## ASSESSMENT REPORT

### OAKDALE CENTRAL, HORSLEY PARK MP 08\_0065 MOD 4 & SSD 6078 MOD 5

This report is an assessment of a request to modify the Concept Plan Approval (MP08\_0065) and the State Significant Development approval (SSD 6078) for the Oakdale Central warehouse and distribution centres (Lots 1C, 2B and 3) at Horsley Park. The request has been lodged by Willow Tree Planning, on behalf of Goodman Property Services (Aust) Pty Ltd (the Applicant), pursuant to section 75W and 96(2) of the *Environmental Planning and Assessment Act 1979* (EP&A Act).

**Figure 3** Proposed site layout plan

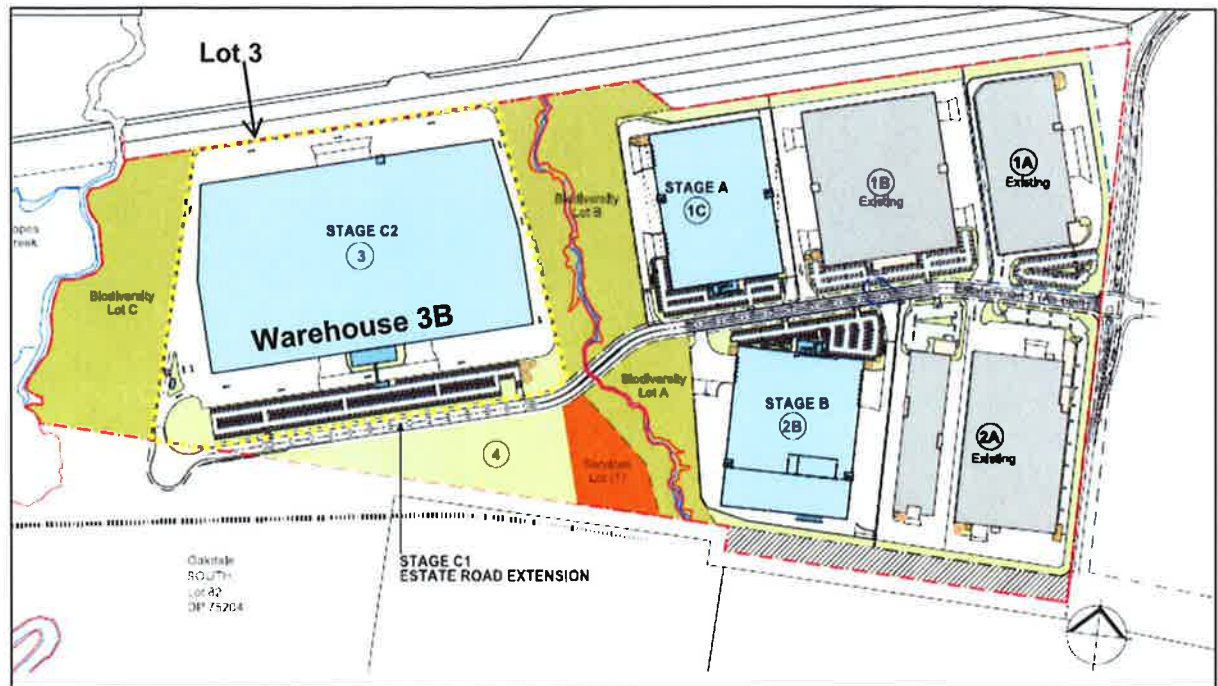
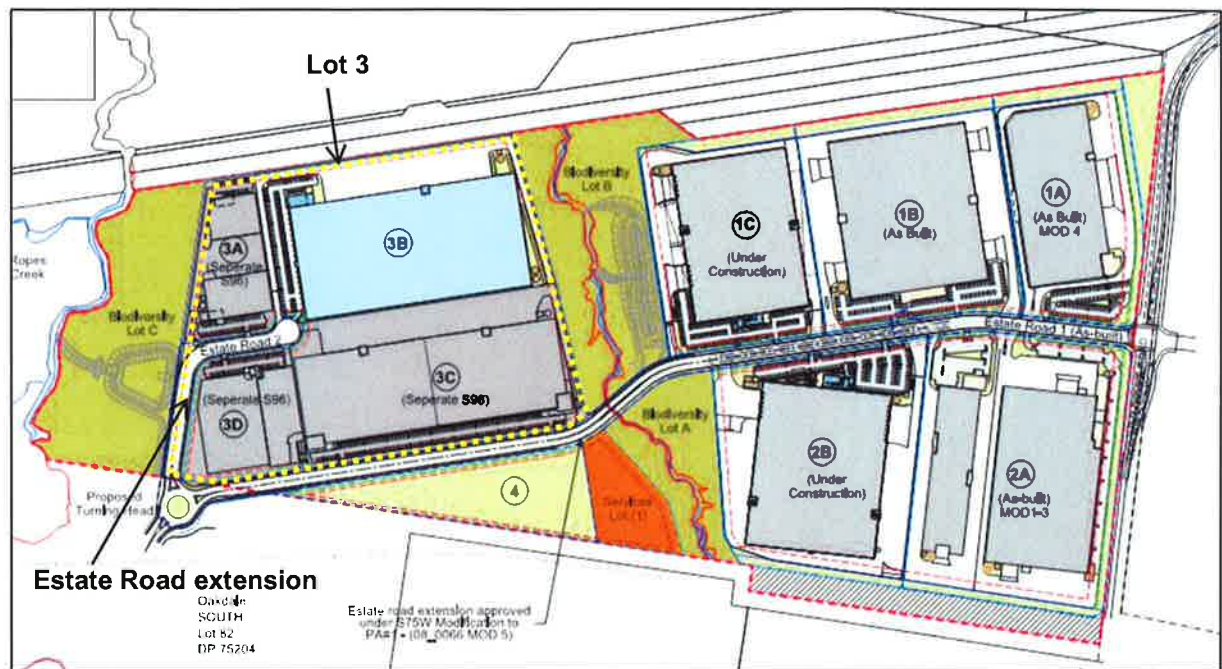
- allow for five separate building envelopes of various sizes on Lot 3, instead of a single large building envelope;
- extend the Estate Road to provide better access into Lot 3; and
- amend the Lot 3 western boundary to provide the Estate Road reserve.

A comparison of the approved and proposed Concept Plan is provided at **Figures 2 and 3**.

- the revised building envelopes on Lot 3 are generally consistent with the type of development contemplated under the approved Concept Plan and Design Guidelines;
- the proposed modifications result in a small reduction in floor space, with the total building area on Lot 3 reducing by 2,346m<sup>2</sup> (from 88,265m<sup>2</sup> to 85,949m<sup>2</sup>), ensuring no additional traffic or other environmental impacts would arise;
- the visual impacts of the amended building envelopes on Lot 3 would be generally consistent with the warehouse development within the Concept Plan site and can be

The Department is satisfied replacing a single large warehouse with five smaller warehouse buildings would allow the Proponent to respond to market demands without resulting in any significant additional impacts. On this basis, the Department's assessment concludes that the proposed modifications to the Concept Plan are acceptable.

**Figure 4** Proposed layout Lot 3

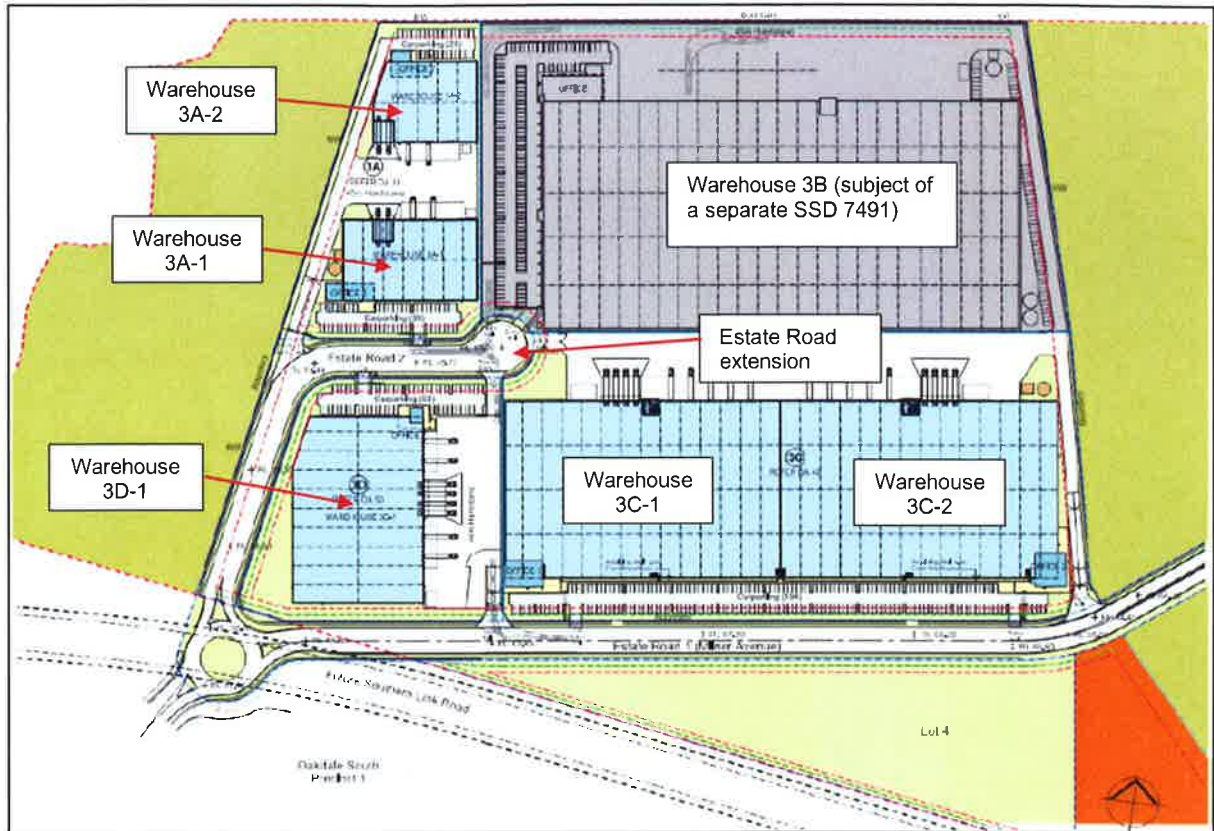
The proposed SSD modification seeks approval to remove an area of land (incorporating the proposed Warehouse 3B) from the SSD 6078 approval, delete the previously approved building on the site, and replace it with four smaller warehouse buildings, together with an extension to the Estate Road from Millner Avenue. The detailed layout is shown in **Figure 4**.

The Department also notes Council raised concern in relation to access to Warehouse 3B, which would partly rely on access over land associated with Warehouse 3C, requiring a right of carriageway should Lot 3 be subdivided into separate lots. The Applicant has confirmed there is no intention to subdivide Lot 3, and therefore there is no need to create a right of carriageway to ensure access to Warehouse 3B. However, the Department notes the plans and documentation submitted with the modification consistently refer to Lots 3A to 3D and the plan of subdivision identifies land areas for Lots 3A to 3D in place of the previous single Lot 3. Therefore, for clarity, a condition is recommended on both the Concept Plan approval, and the SSD approval, requiring that Lot 3 be retained as a single title and that the consent does not include subdivision of Lot 3 into separate development lots.

The Department considers the access arrangements are satisfactory, subject to the amendment of the relevant condition restricting service vehicles to Warehouse 3A to a maximum 19m articulated vehicle.
